AMENDMENTS TO THE DRAWINGS

Annotated Marked-up Drawing Application No. 10/788783 By: Donald A. Serino

Title: Ruggedized Ethernet Connector Assembly
Atty. Docket No. ALS-018

Fig. 1 PRIOR ART

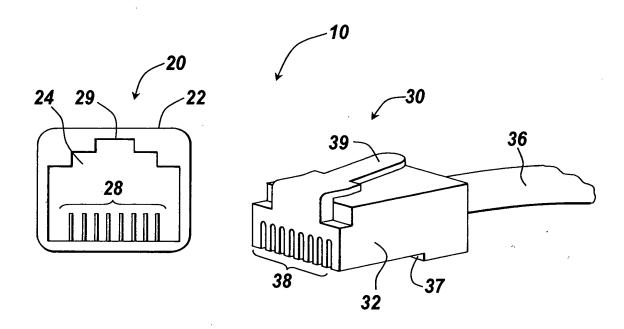
The attached sheet of drawings includes changes to Figure 1. This sheet, which includes Figure 1 only, replaces the original sheet including Figure 1. In Figure 1, a -- Prior Art-- designation has been added.

Applicants have amended Figure 1 to include a ---Prior Art--- designation, as requested on page 2 of the Office Action.

Claim 14 also distinguishes patentably over the Applicant's Admitted Prior Art (AAPA) of Figure 1, because the AAPA does not disclose a plug receptacle sized and configured to receive a *wired end* of a <u>separate</u> plug, such that the opposite end of the plug may mate with a corresponding jack. Rather, the so-called jack 20 of the conventional network connector, which

the Examiner considers to be a "plug receptacle", is configured to receive the *mating* end of the male connector half, rather than house the <u>wired</u> end of the plug.
